31 March 2025
Our Ref: 22296A.2CE_OBJ

RE: Submission to the NSW Department of Planning, Housing and Infrastructure

SSD – 73603959: Demolition, Site Preparation, Alterations and Additions to existing Residential Care Facility (RFC), Construction of 132 Independent Living Units (ILUs), Landscaping Works and Lot Consolidation at Nos. 1610, 1614-1634 Pacific Highway & 5 Munderah Street, Wahroonga (Lot 1 DP 1256199, Lot 3 DP 339734, Lot A DP 410419)

Figure 2 Proposed Alternative Staging

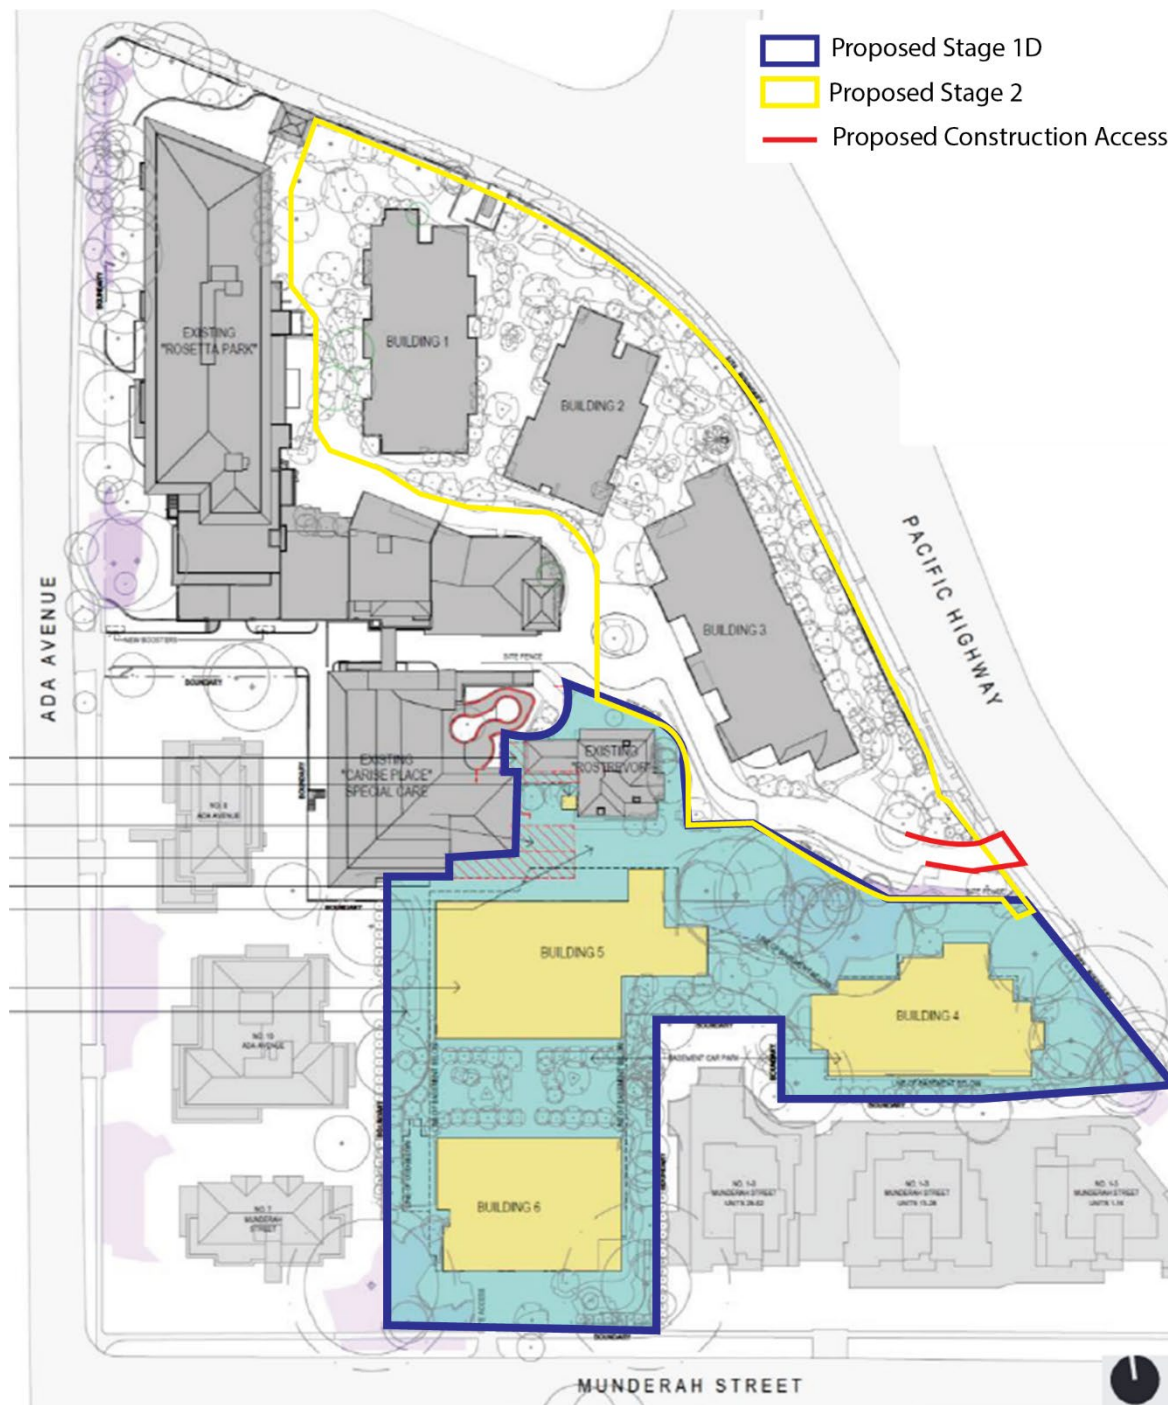
Given the lengthy construction period it is suggested that the construction of Building 4, 5 and 6 should be prioritised to minimise the impact on the adjoining RFBs. Construction of Building 4, 5 and 6 first would provide a partial barrier to the adjoining RFBs for the 14 month construction period of Stage 1D.

The alternative staging approach to minimise impacts is outlined in **Figure 2** below.

The cumulative impact of the proposed staging of the development on the residents of the adjoining RFBs is unacceptable. The staging of the project should be reconsidered to decrease the timeframe of the impact on these residents.

- Stage 1A- Enabling works (Approx.4 months) Impact on residents of UPA
- Stage 1B – Demolition Works (Approx.4 months) Impact on adjoining RFBs
- Stage 1C – UPA Administration (Approx. 2 months) Impact on adjoining RFBs
- Stage 1D – Construction Buildings 4, 5 & 6 (Approx. 18 months) Impact on adjoining RFBs and UPA
- Stage 2 – Construction Buildings 1, 2 & 3 (Approx. 14 months) Impact on residents of UPA only

Figure 4 Existing solar impacts 21 June on 1-3 Munderah Street (North)

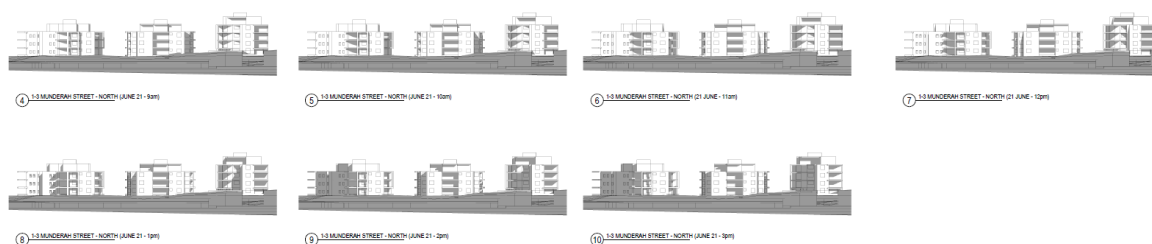
Whilst these percentage are compliant under the ADG provisions, Table 29 of the EIS and the Architectural Drawings indicate that the existing solar access to 1-3 Munderah decreases from 97% (97.6%) to 81 %. A decrease in solar access of 16.6% is unacceptable. The design of Buildings 4, 5 and 6 should be reconsidered so that they have a non-worsening solar impact on the neighbouring properties.

The existing solar impact on 1-3 Munderah Street on 21 June is illustrated by the shadow diagrams below provided in the Architectural Drawing set – refer to Drawing DA6601C.

Figure 5 Existing solar impacts 21 June on 1-3 Munderah Street (West)

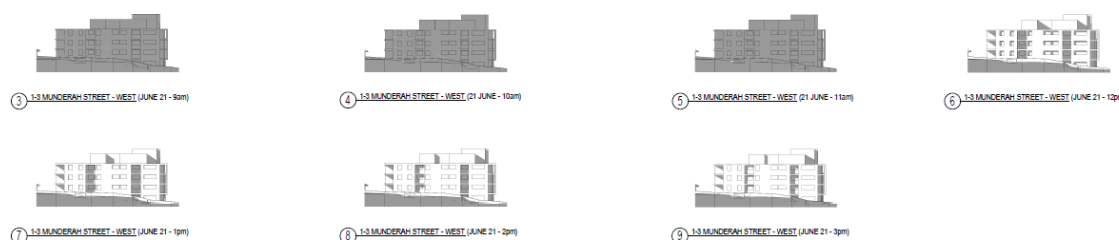
The existing solar impacts on 1-3 Munderah Street (West) is illustrated in Drawing DA6602 C.

It is noted that Drawing DA6602C incorrectly refers to the shadow diagrams impacting 1-3 Munderah Street (existing), however it is assumed these are for 7 Munderah Street as it depicts a single building.

Figure 6 Proposed solar impacts 21 June on 1-3 Munderah Street (North)

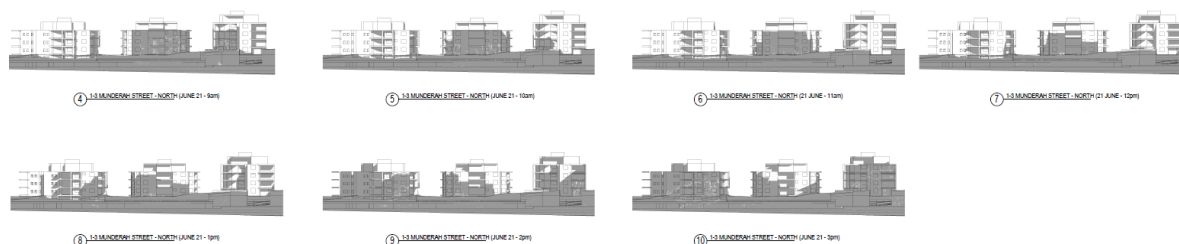
The proposed solar impact on 1-3 Munderah Street on 21 June is illustrated by the shadow diagrams provided in the Architectural Drawing set – refer to Drawings DA66104C.

From the diagrams above it is clear that there will be a greater solar impact to 1-3 Munderah Street throughout the day between 9am to 3pm particularly on the western elevation.

Figure 7 Proposed solar impacts 21 June on 1-3 Munderah Street (West)

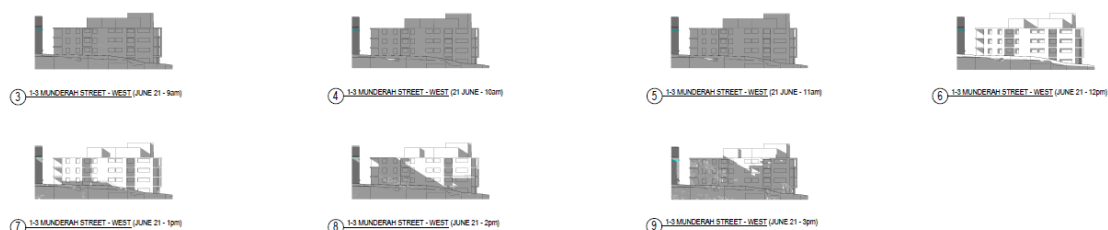
The proposed solar impacts 21 June on 1-3 Munderah Street West elevation is shown on Architectural Drawing DA6605 C.

Figure 8 Existing solar impacts 21 June 10 Ada Street (East)

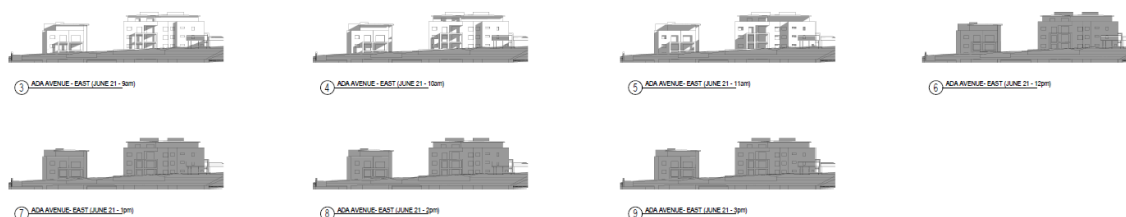
The existing solar impacts on 8-10 Ada Street on 21 June are illustrated by the shadow diagram provided in the Architectural Drawing Set – refer to Drawing DA6603C.

These are the only shadow diagrams prepared for 8-10 Ada Street. From the diagrams above it is clear the 10 Ada Avenue will be more impacted by the proposed development at 9am on 21 June than the existing development.

Figure 9 Proposed solar impacts 21 June on 8-10 Ada Avenue

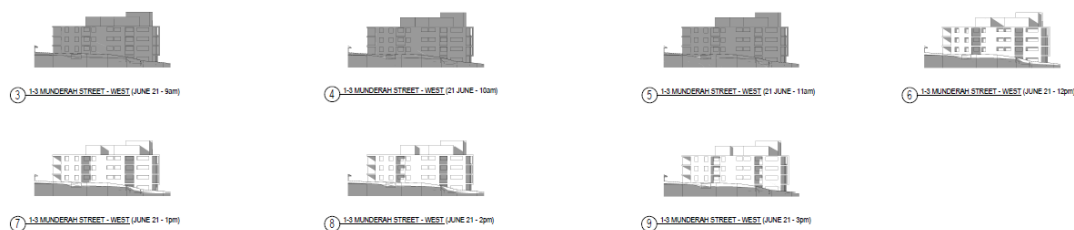
The proposed solar impacts on 8-10 Ada Avenue are illustrated by the shadow diagrams provided in the Architectural Drawing set – refer to Drawings DA6606C.

Figure 10 Non-compliant building separation

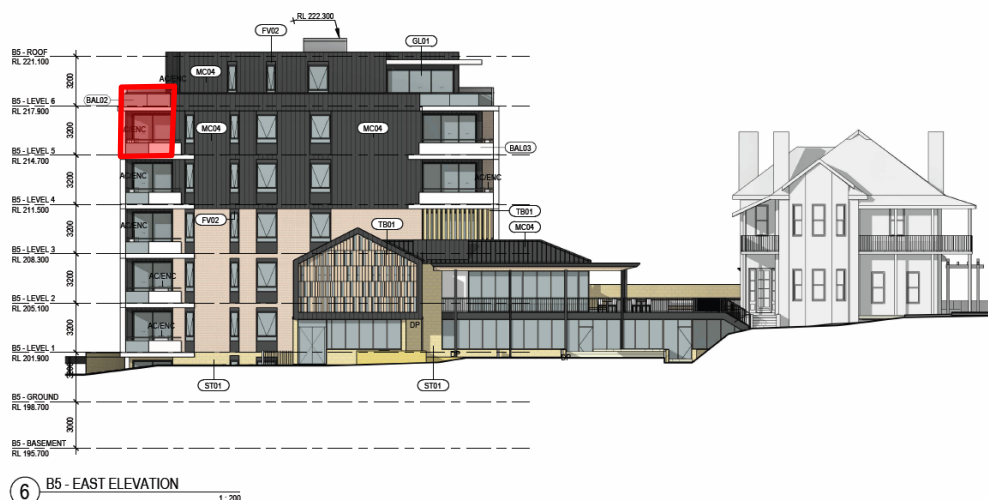
Level 5 of Building 5 does not provide 9m building separation to No.s 8-10 Ada Avenue as required by Part 3F of the ADG (**Figure 10**, outlined in red). Given the site area compliance can be readily achieved and building massing shifted in order to comply with the ADG.
